Red Rock Canyon State Park

Addendum to the Final General Plan and Final Environmental Impact Report

March 27, 2023

Figure 3. Closeup of Sierra View Road through the Northwest Corner of the Park; SR 14 legal crossing is at the blue dot location.

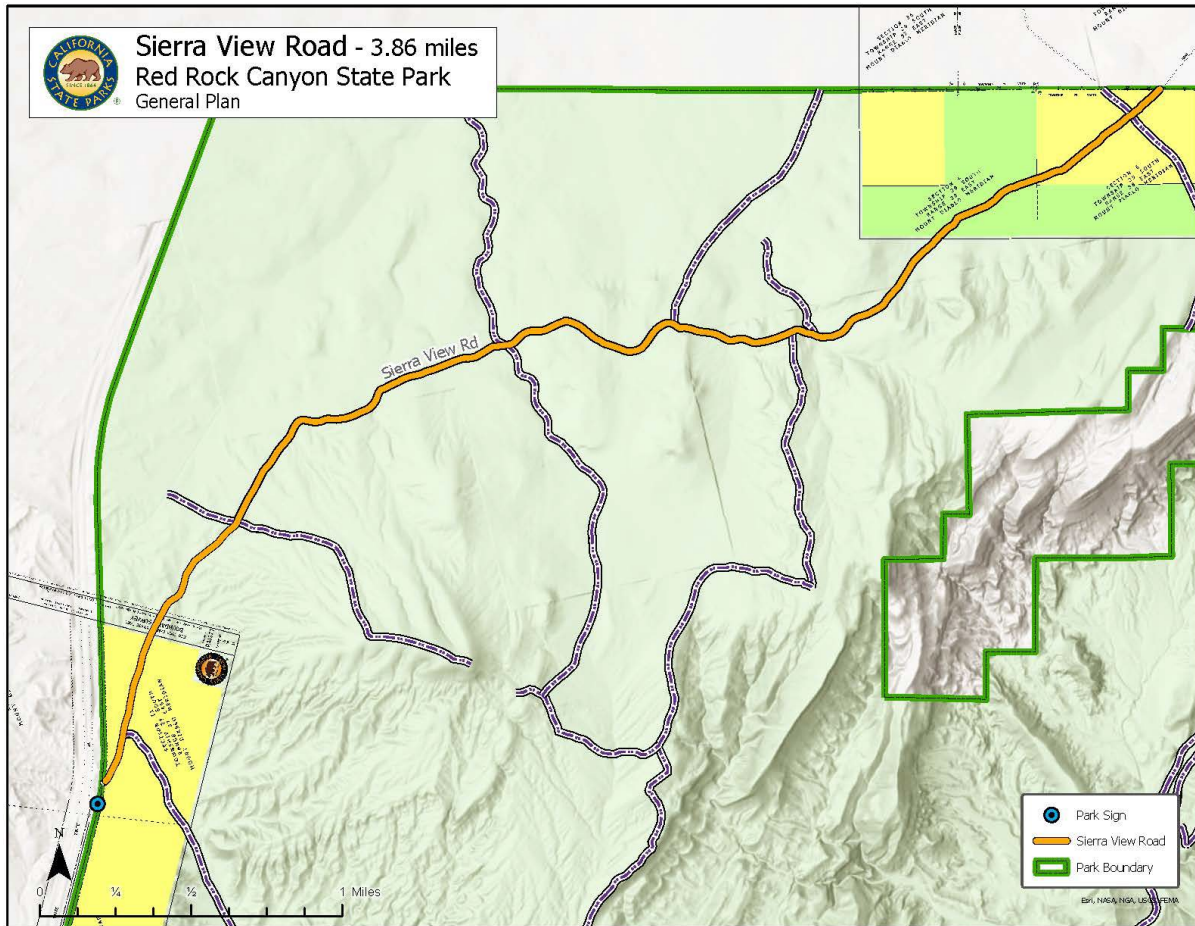
Upon receiving the comment on March 9 stating that the commenter believes the segment was significantly longer than the 3.1 miles stated during the commission meeting and thus included in the approved General Plan, State Parks reexamined the GIS data for Sierra View Road and park boundaries and determined that minor errors occurred during calculations. Figure 3 shows Sierra View Road through the Park, and Figure 4 and Table 1 show the corrected Sierra View Road segments and mileage, which were determined to add up to 3.86 miles.

Figure 4. Sierra View Road route segment measurements

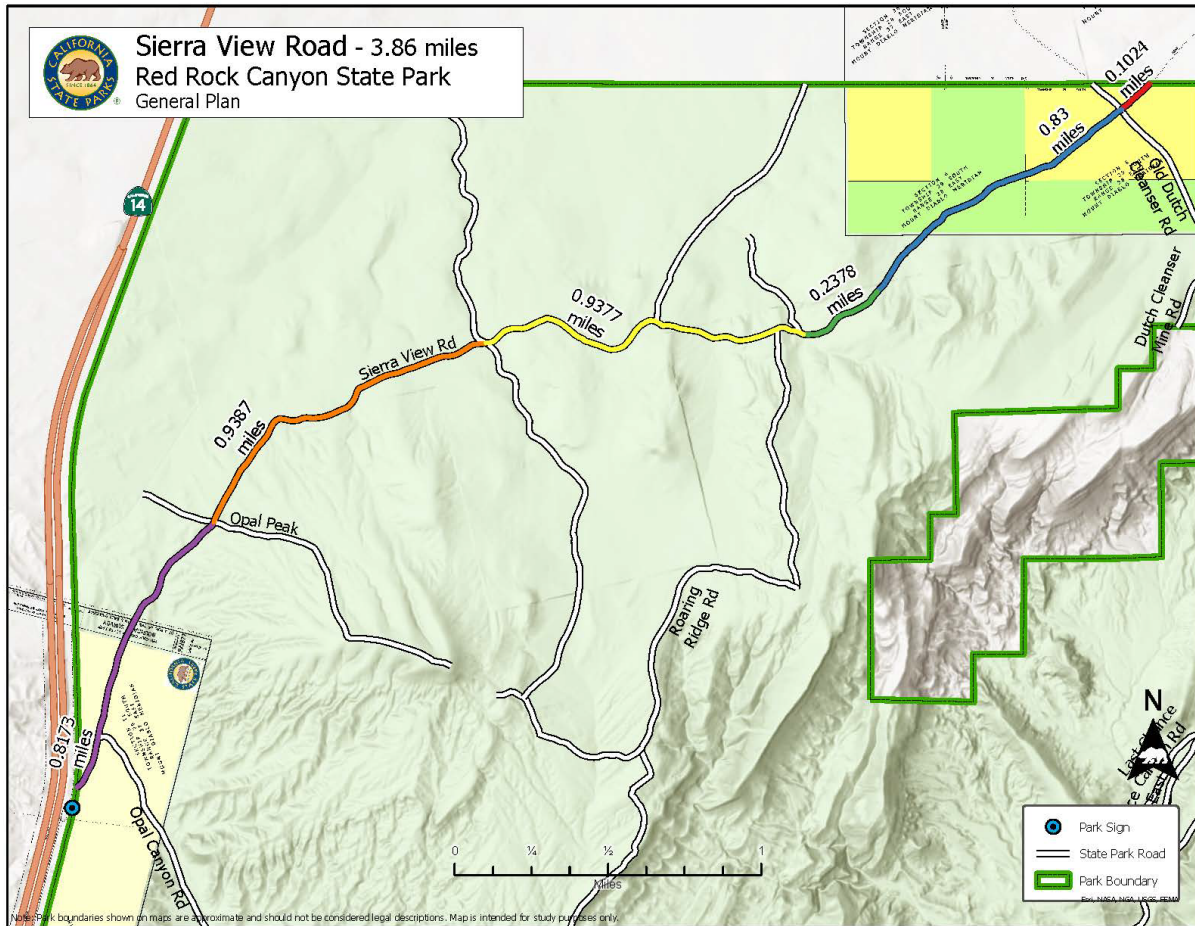
In response to this re-calculation, this Addendum to the Red Rock Canyon State Park General Plan and EIR revises the length of Sierra View Road that would allow continued OHV travel through the Park from 3.1 miles to 3.86 miles. The change in length of Sierra View Road does not necessitate any changes to the EIR analysis or its impact conclusions. Vehicle travel on Sierra View Road is currently occurring and will continue to occur with General Plan implementation. The EIR did not identify any significant impacts resulting from General Plan Implementation, including continued vehicle travel on Sierra View Road. The length change merely conflicts with the CVC, which states that only three miles shall be designated in a State Park Unit to allow OHV access, and the 3.86 miles are beyond those limits.

Route Segment	Calculated Length in Feet	Calculated Length in Miles	GIS Identification Number
Sierra View Rd Segment (purple line in figure 4)	4,950.9297	0.9377	GIS0071006
Sierra View Rd Segment (orange line in Figure 4)	4,956.3037	0.9387	GIS0071013
Sierra View Rd Segment (yellow line in Figure 4)	4,315.4624	0.8173	GIS0071020
Sierra View Rd Segment (green line in Figure 4)	1,255.6355	0.2378	GIS0074485
Sierra View Rd Segment (blue line in Figure 4)	4,382.2831	0.8300	GIS0074486
Sierra View Rd Segment (red line in Figure 4)	540.6449	0.1024	GIS0081463
Total Segment Lengths	20,401.2592 feet	3.8639 miles	N/A
